Townsend - South

Environmental Assessment and **“Nationwide” Section 4(f) Evaluations**

Project NH-F 8-4(16)78; Control No. 1420
Broadwater County, Montana

REVISED
ENVIRONMENTAL ASSESSMENT
and
"NATIONWIDE" SECTION 4(f) EVALUATIONS

Townsend - South
REVISED Figure 3
 Lane Configurations
 Preferred Alternative

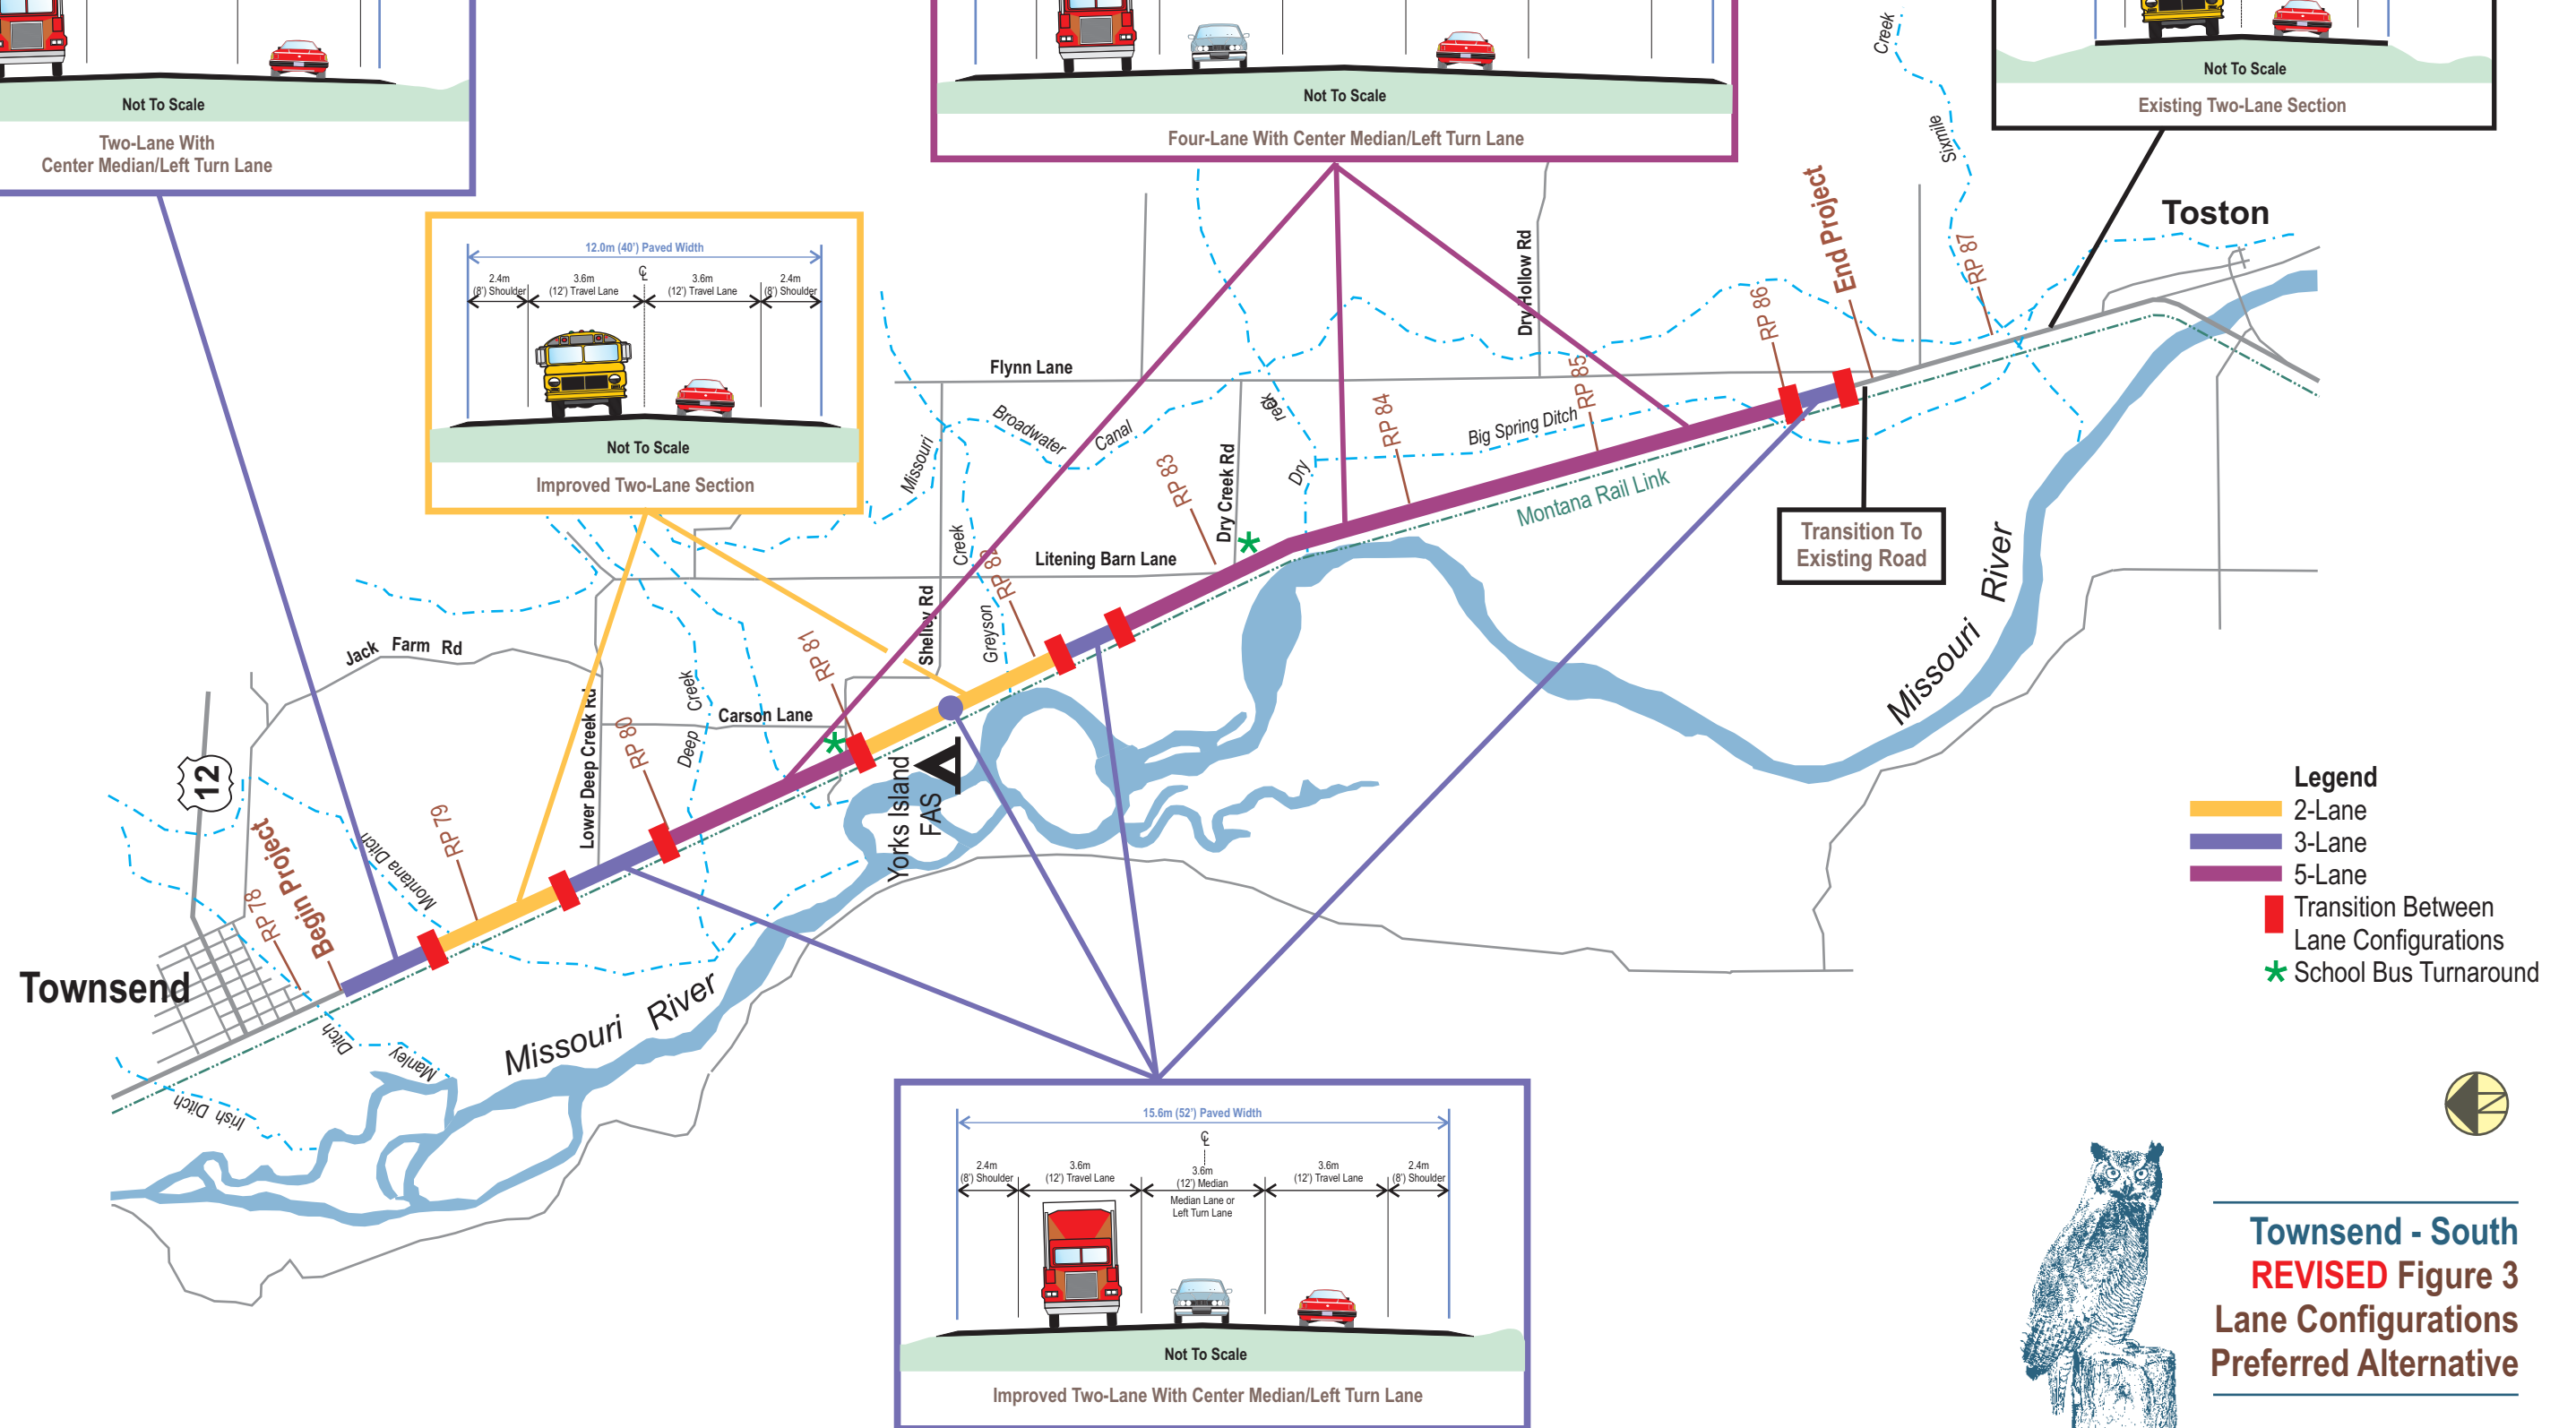
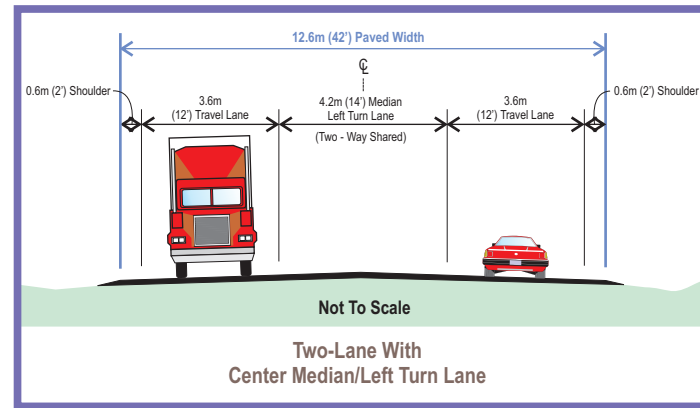
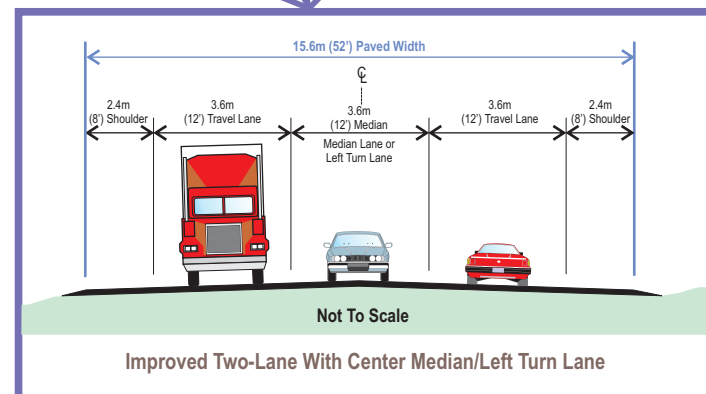
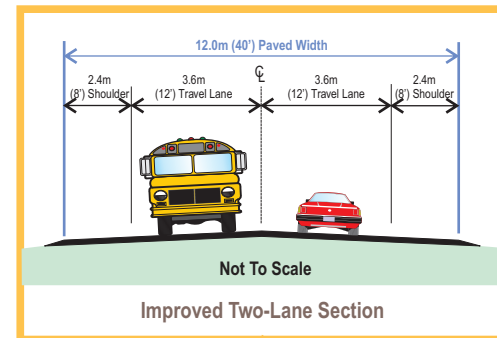
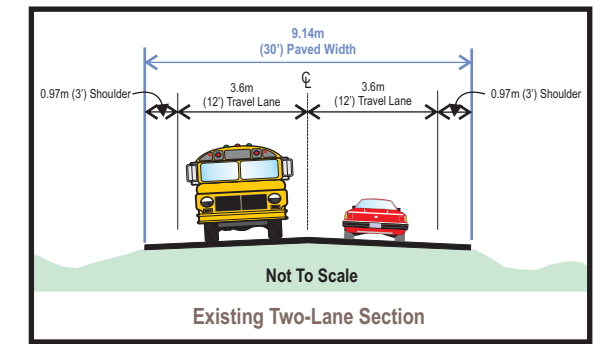
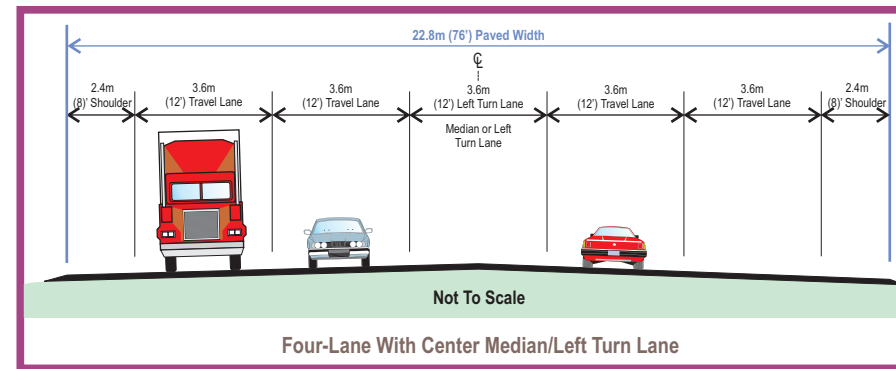
This document also allows MDT to clarify design details for the passing areas included with the Preferred Alternative. The graphic showing proposed lane configurations (**FIGURE 3** in the EA distributed in November 2005) inadvertently showed passing areas as undivided four-lane sections. MDT proposes that passing areas be 22.8 meters (76-feet) wide and consist of four driving lanes and a center median/left turn lane. Although the EA disclosed that the passing areas may include sections with five-lanes, the document did not clearly represent that passing areas would be developed with five-lane typical cross-sections.

FIGURE 3 in the EA showed three areas in the project corridor where improved two-lane sections would be provided. The Preferred Alternative includes only two areas with an improved two-lane typical section and has other adjoining areas with three-lane typical sections. Additionally, the figure did not provide any indication of where transitions occur between various lane configurations. The figure suggested abrupt changes would exist between areas with different lane configurations. In reality, gradual transitions would be constructed in areas where the roadway width and lane configurations change.

The discrepancies between the proposed lane configurations shown on **FIGURE 3** in the EA and MDT's design proposal were disclosed at the December 15, 2005 public hearing. The display boards used by MDT during the engineering presentation at the hearing accurately showed the proposed lane configurations for this project. These aerial photo displays were frequently referenced during the presentation, the oral comment period, and during informal discussions with the public.

Circulating a Revised EA allows MDT to accurately show the lane configurations associated with the Preferred Alternative and eliminate any confusion that may have been created by the original lane configuration graphic.

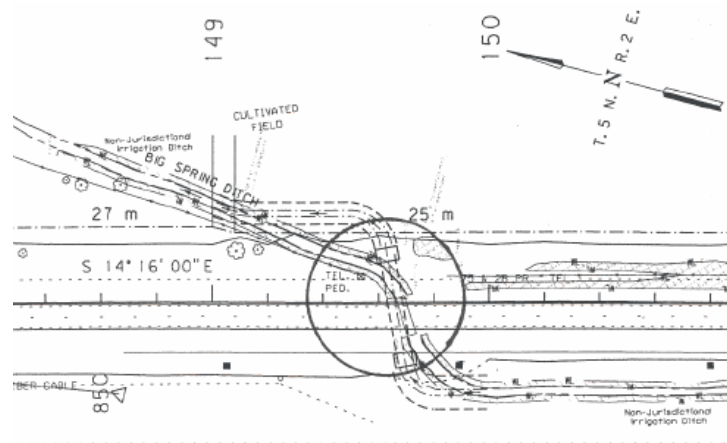
COMMENT 2B: *Another thing, on one of the slides it showed three bridges, so I don't know if the Spring Ditch Bridge doesn't count. On Spring Ditch, when the current highway went in, they changed the alignment of the ditch and that bridge needs to go back in on the skew because we've had a run-in with the local maintenance crew when we cleaned the ditch because the ditch is at a right angle to the highway.*

RESPONSE: We assume this comment refers to the Big Springs Ditch crossing on U.S. Highway 287 which is a concrete box culvert and not a bridge. A preliminary design drawing shown below indicates the existing concrete box culvert would be replaced with a new irrigation pipe beneath the highway and the inlet and outlet channels for the ditch would be realigned. The dashed lines shown in the figure indicate the proposed new alignment of the ditch.

The new pipe beneath the highway would not be skewed to the same degree as the existing culvert. Realigning the ditch so as much of this irrigation facility is outside the new right-of-way and away from roadway should help local maintenance efforts.
